PORSCHE OF NOVI JSP22-32

Public Hearing at the request of Lithia Motors, Inc. for approval of the Preliminary Site Plan, Special Land Use Permit, and Stormwater Management Plan. The subject property is approximately 8.15 acres and is located north of Ten Mile Road on the west side of Haggerty Road in the B-3, General Business District. The applicant is proposing to demolish an existing building in the southeast portion of the site and redevelop the area in order to build a 19,170 square foot, two-story car dealership building to be used by Porsche of Novi.

PLAN REVIEW CENTER REPORT

NFE JOB NO. SHEET NO.
 1921-05 C1

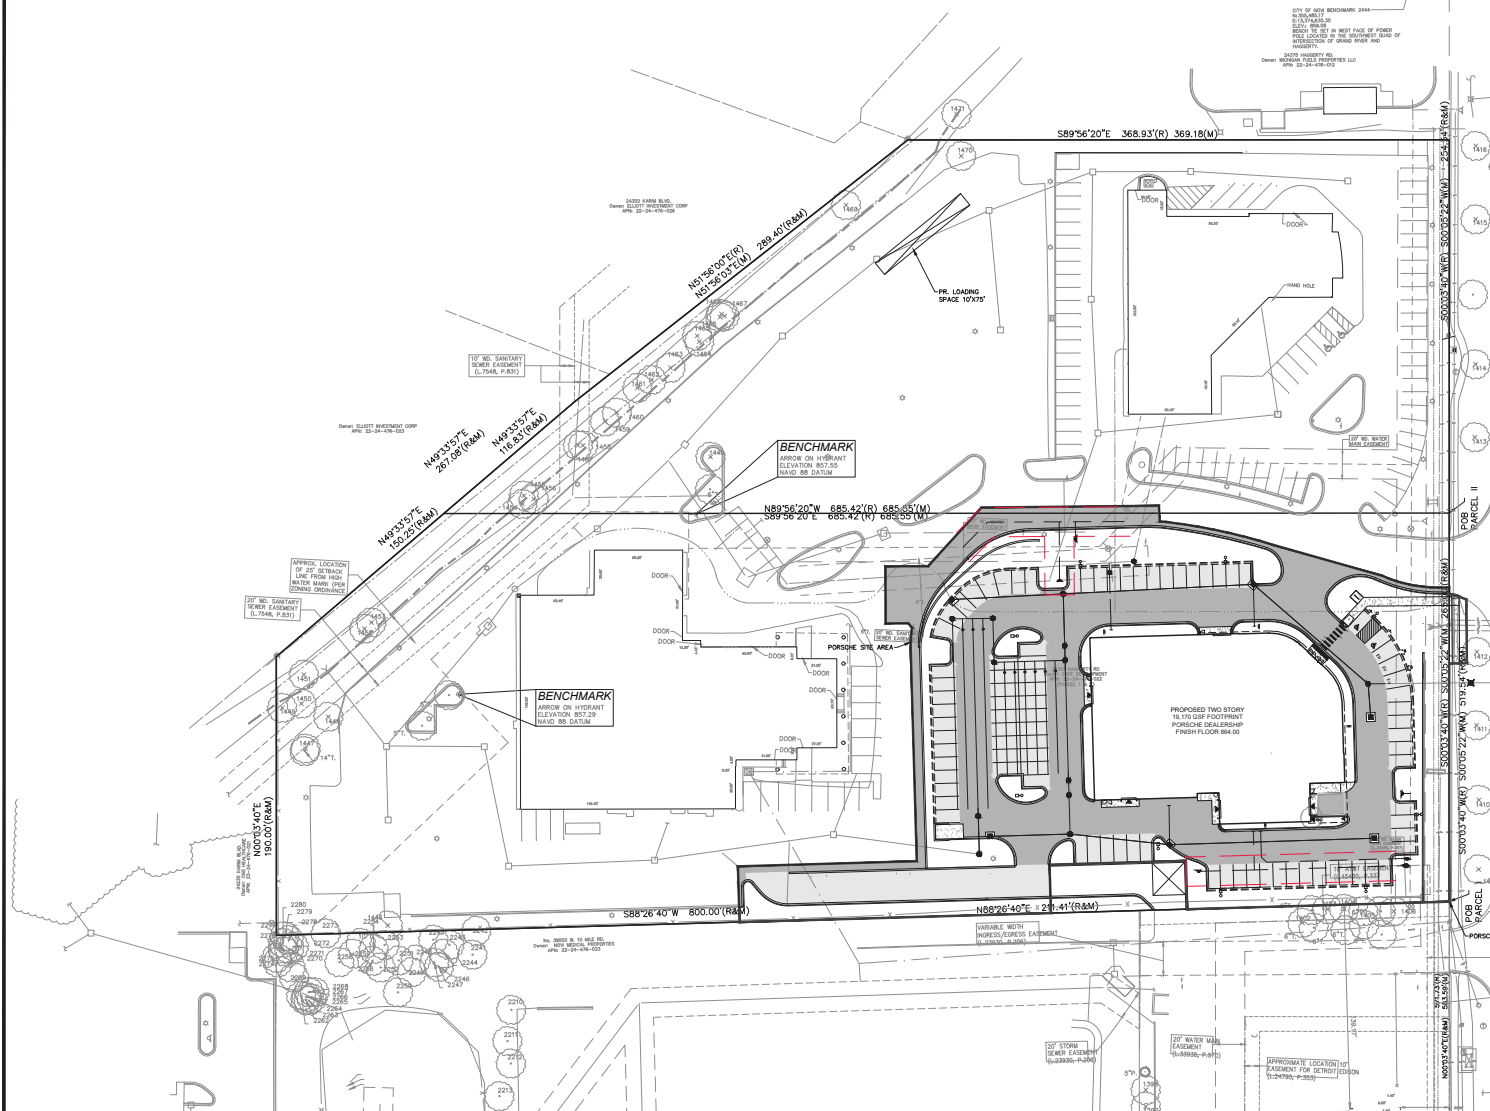
INTERNAL SITE OPERATIONS				
No.	Item	Proposed	Compliance	Remarks
11	Loading zone ZO 5.4	Indicated	Not Met	The note on sheet C3 indicates the loading area to be 10' x 75' but the callout on sheet C1 shows 10' x 45'. Loading zone is also not located in proximity to the building.
12	Trash receptacle ZO 5.4.4	Included in rear yard	Met	
13	Emergency Vehicle Access	Turning movements provided	Met	
14	Maneuvering Lane ZO 5.3.2	24'	Met	
15	End islands ZO 5.3.12			
15a	Adjacent to a travel way	3' shorter, 5' outer radius	Partially Met	Outer radius should be 15'

NEE JOB NO. SHEET NO.:
1921-05 C3

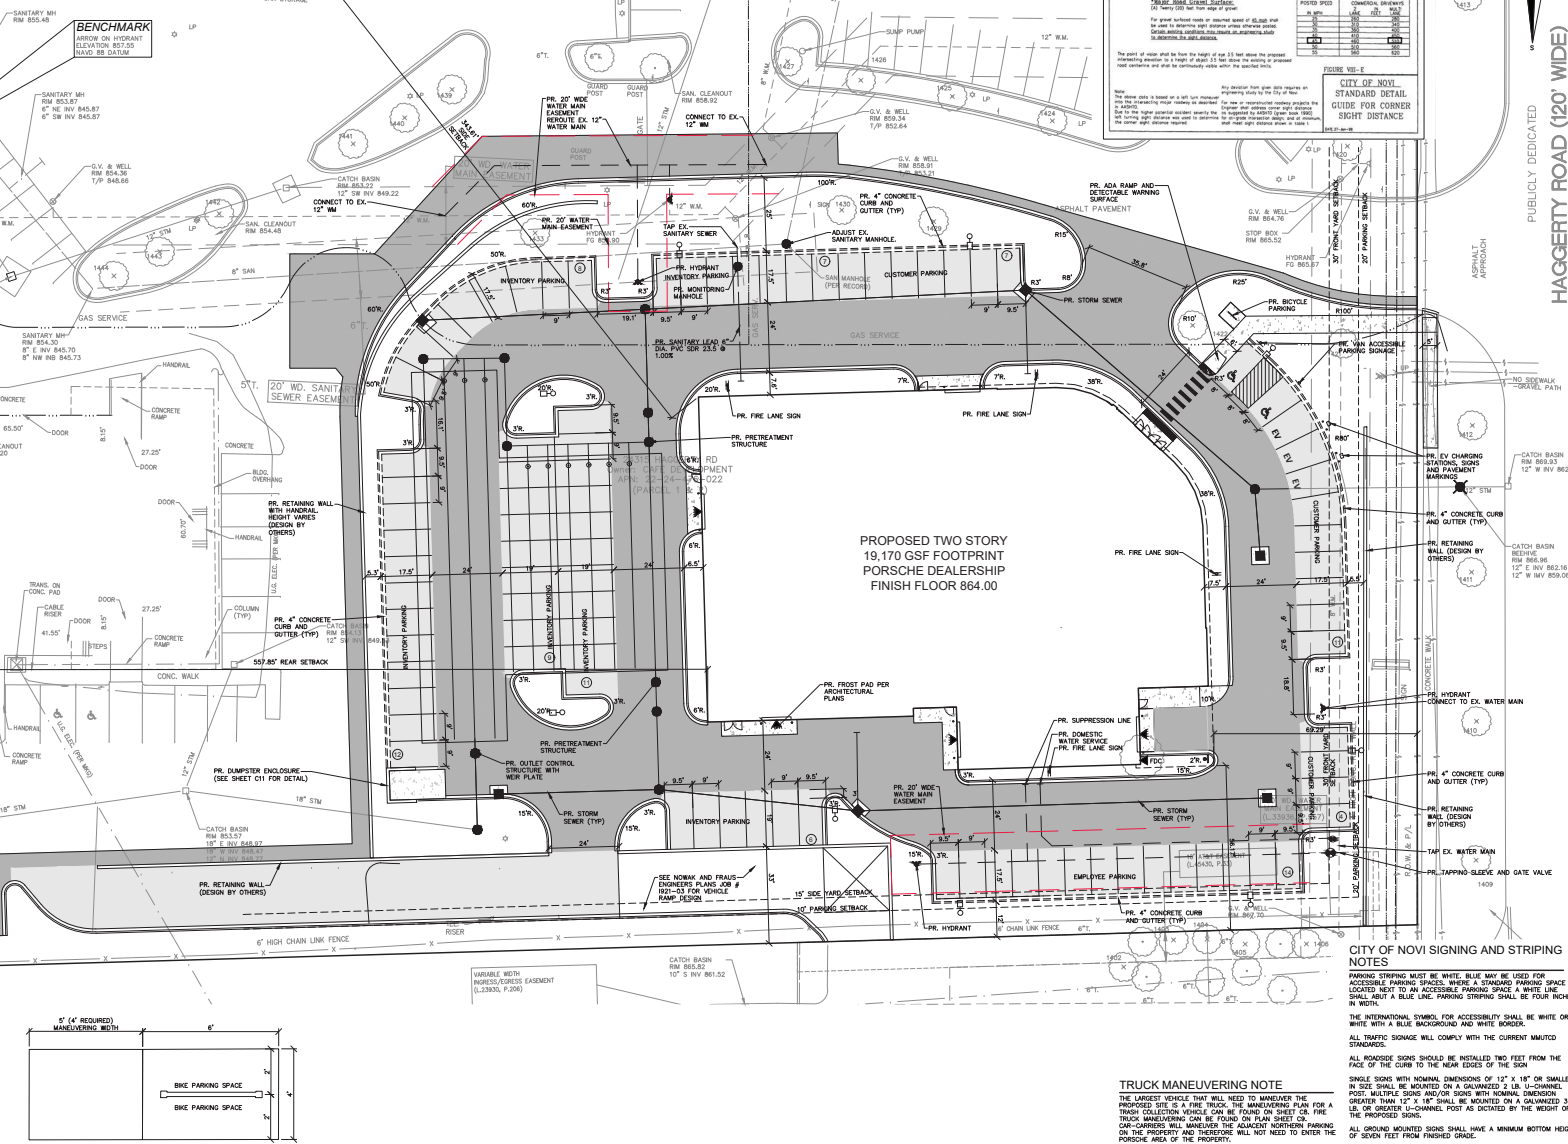
SIGNING AND STRIPING				
No.	Item	Proposed	Compliance	Remarks
32	Signing: Sizes MMUTCD	Included	Partially Met	Include R7-8 sign on sheet C3 in future submittals.
33	Signing table: quantities and sizes	Not included	Not Met	Include R7-8 signs on sheet C3 in future submittals.
34	Signs 12" x 18" or smaller in size shall be mounted on a galvanized 2 lb. U-channel post MMUTCD	Included	Met	
35	Signs greater than 12" x 18" shall be mounted on a galvanized 3 lb. or greater U-channel post MMUTCD	Included	Partially Met	Update sign post in detail with both R7-8 and R7-8P signs.
36	Sign bottom height of 7' from final grade MMUTCD	Included	Met	
37	Signing shall be placed 2' from the face of the curb or edge of the nearest sidewalk to the near edge of the sign MMUTCD	Included	Met	
38	FHWA Standard Alphabet series used for all sign language MMUTCD	Included	Met	
39	High-Intensity Prismatic (HIP) sheeting to meet FHWA retro-reflectivity MMUTCD	Included	Met

40	Parking space striping notes	Included	Partially Met	Barrier Free parking space detail contradicts note on sheet C3. Update detail on sheet C11 to match sheet C3 note.
41	The international symbol for accessibility pavement markings ADA	Included	Met	
42	Crosswalk pavement marking detail	Included	Met	
43	Any Other Comments:	Signing notes on sheet C3 are duplicated.

COMPOSITE FLOOR PLAN
TS1.4

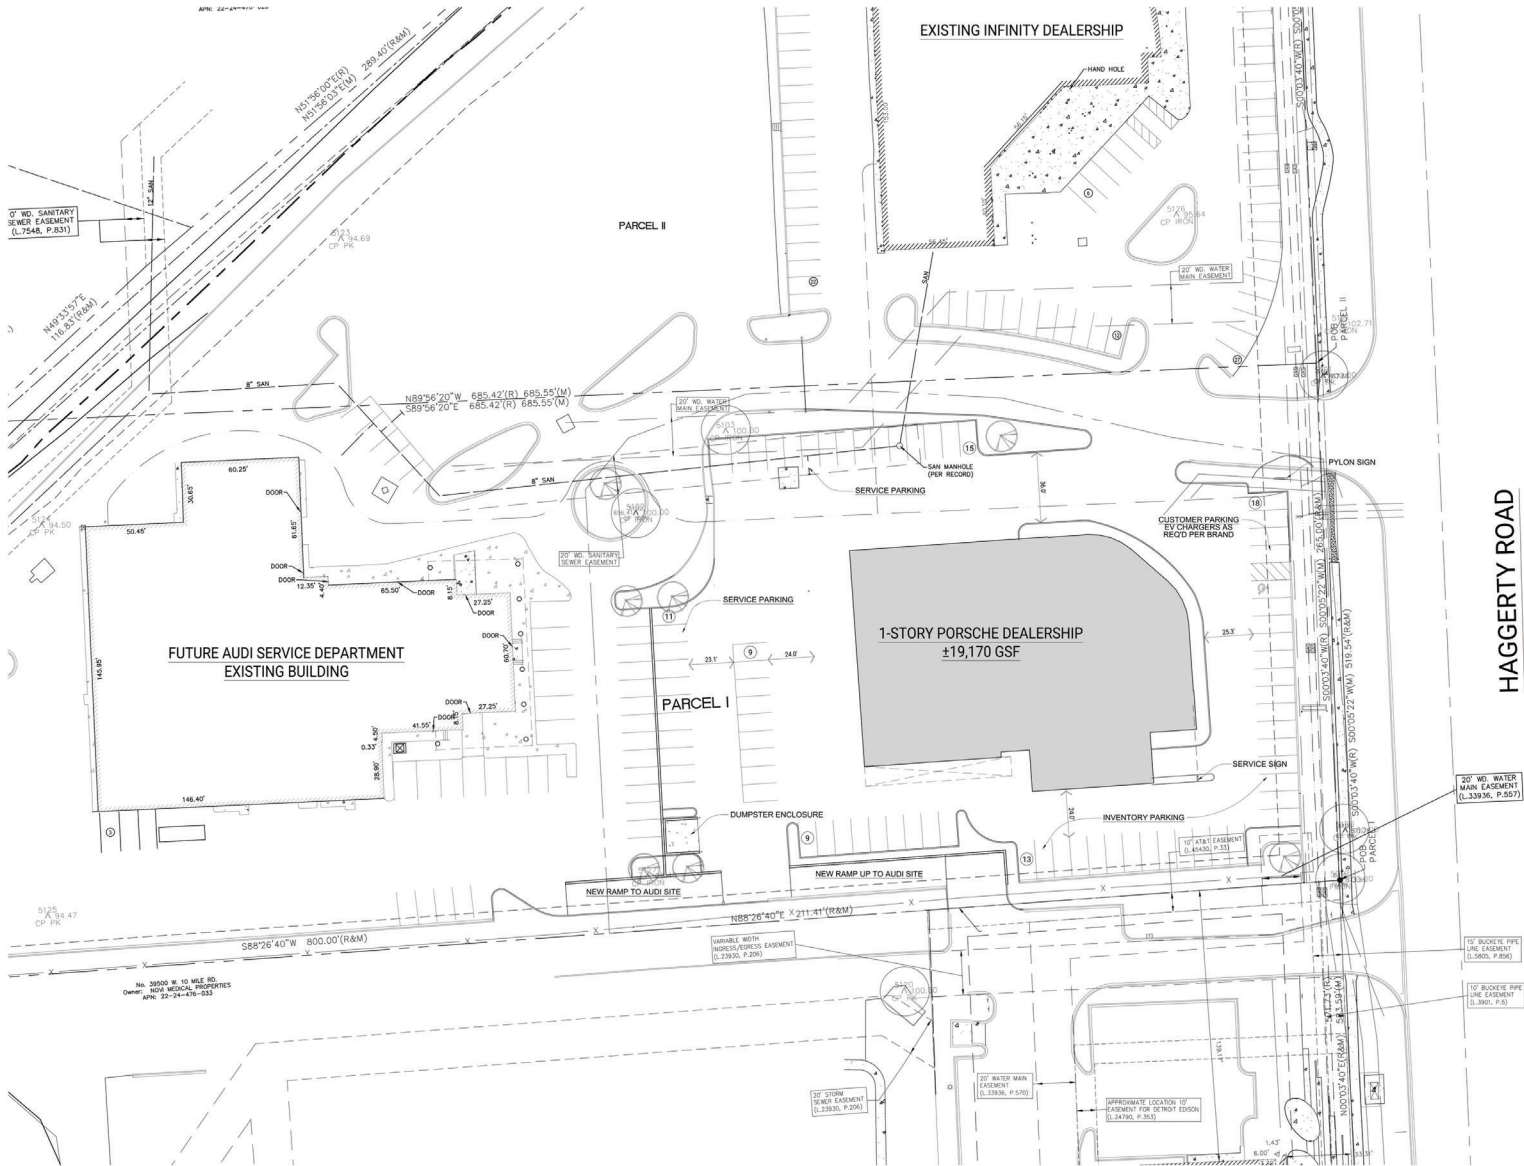
- On plan #TS1.4, Need secondary egress from showroom area to outside. Customers cannot egress from low hazard to high hazard.

EXTERIOR ELEVATIONS
A2.1

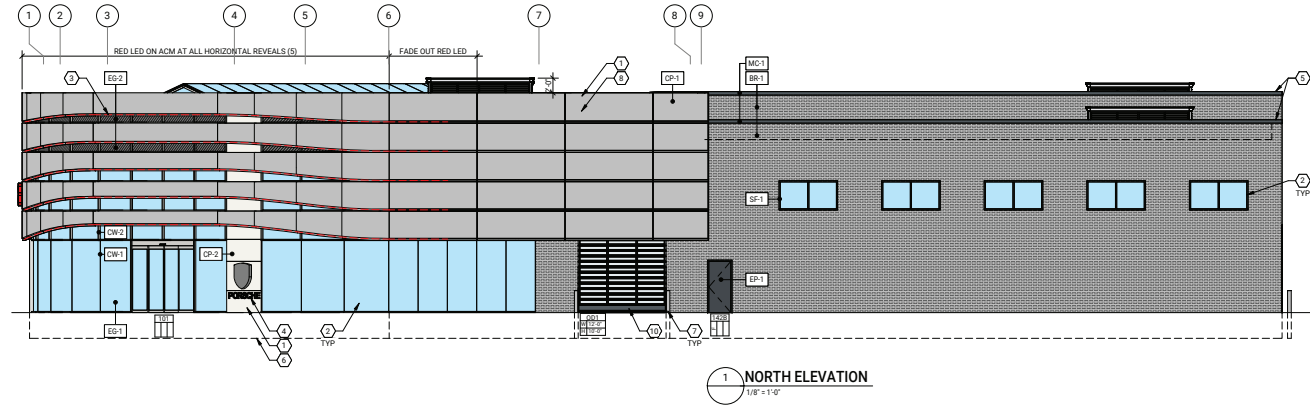
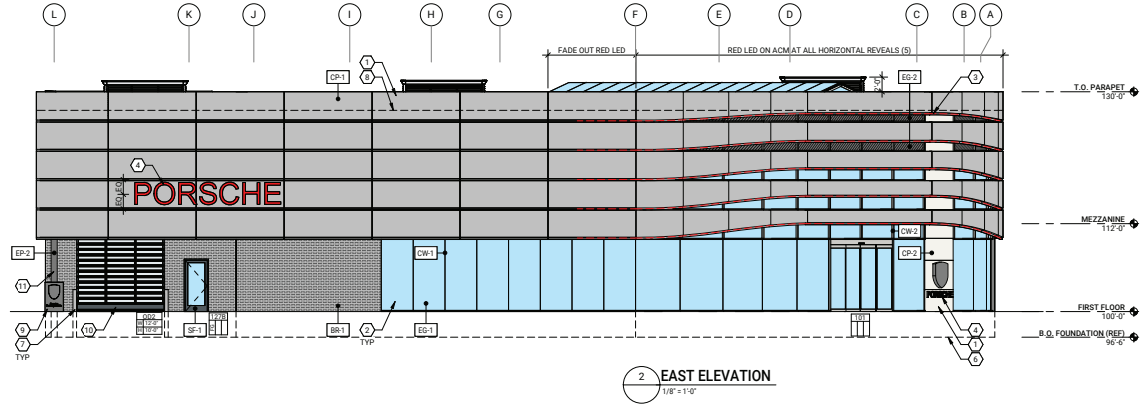
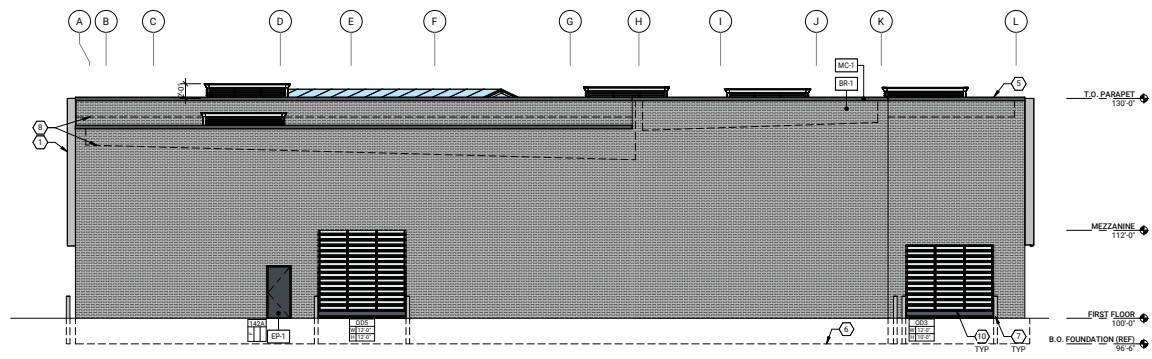
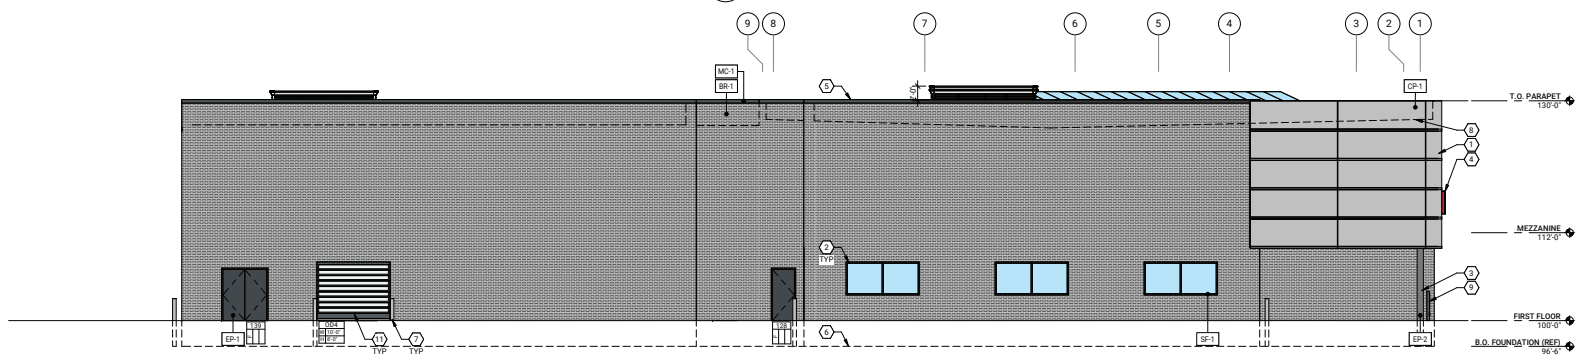
3. Overhead doors (Sec. 3.10.3.A) No truck well, loading dock, overhead door or other type of service bay door shall face a major thoroughfare, nor an abutting residential district. **Overhead doors are proposed facing west, and on the east elevation, which faces a major thoroughfare. The door on the east side is set back about 24 feet from the primary façade, which will help disguise it. Please revise the elevations or seek a variance from the Zoning Board of Appeals.**
